HARTZELL PROPELLER INC.
SERVICE LETTER

HC-SL-61-371

Introduction of Alternate O-ring (p/n C-3317-AR-157)

Visual O-ring Inspection
Figure 1

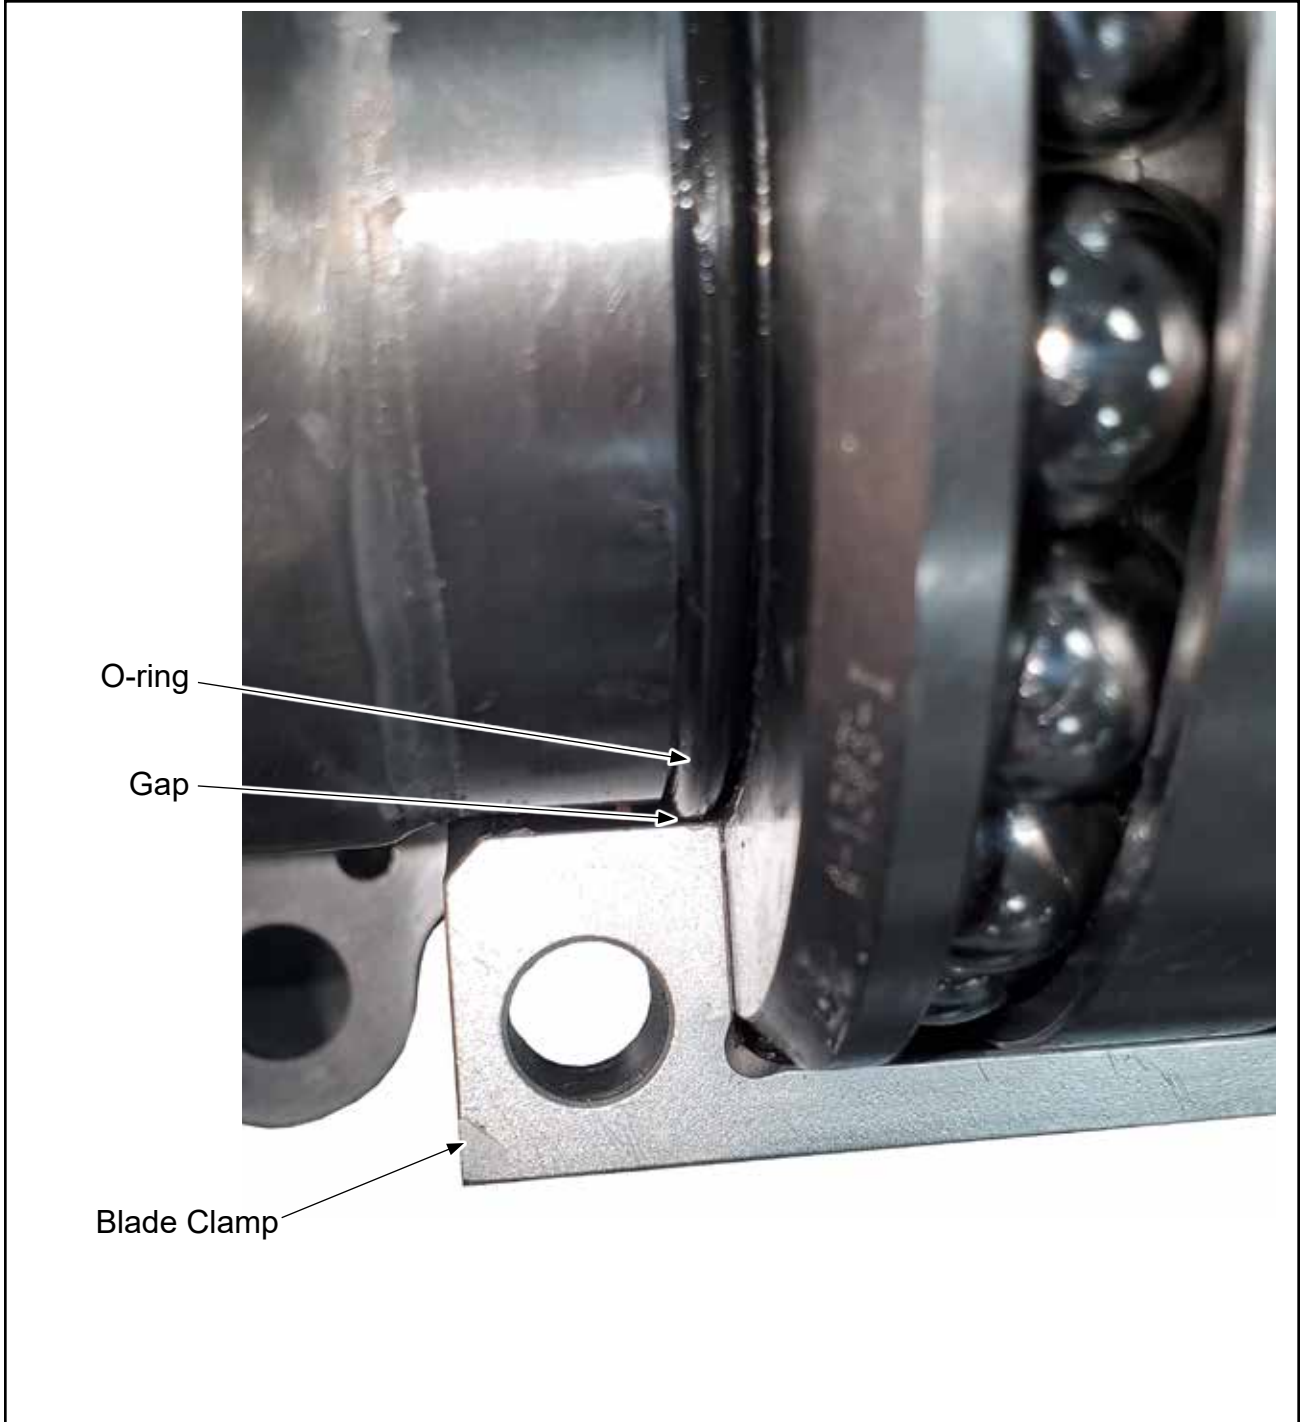
- (1) During the assembly process, install a new C-3317-229 O-ring then check for a gap between the blade clamp half and the O-ring. Refer to Figure 1.
 - (a) If there is no gap between the blade clamp half and the C-3317-229 O-ring, the assembly process can be completed using the C-3317-229 O-ring.
 - (b) If there is a gap between the blade clamp half and the C-3317-229 O-ring, remove the C-3317-229 O-ring and install a new C-3317-AR-157 O-ring.
 - 1 After installing C-3317-AR-157 O-rings, blades, and blade clamps, manually rotate the blades to check for excessive friction.
 - a If there is excessive friction, remove the C-3317-AR-157 O-ring and reinstall the C-3317-229 O-ring.
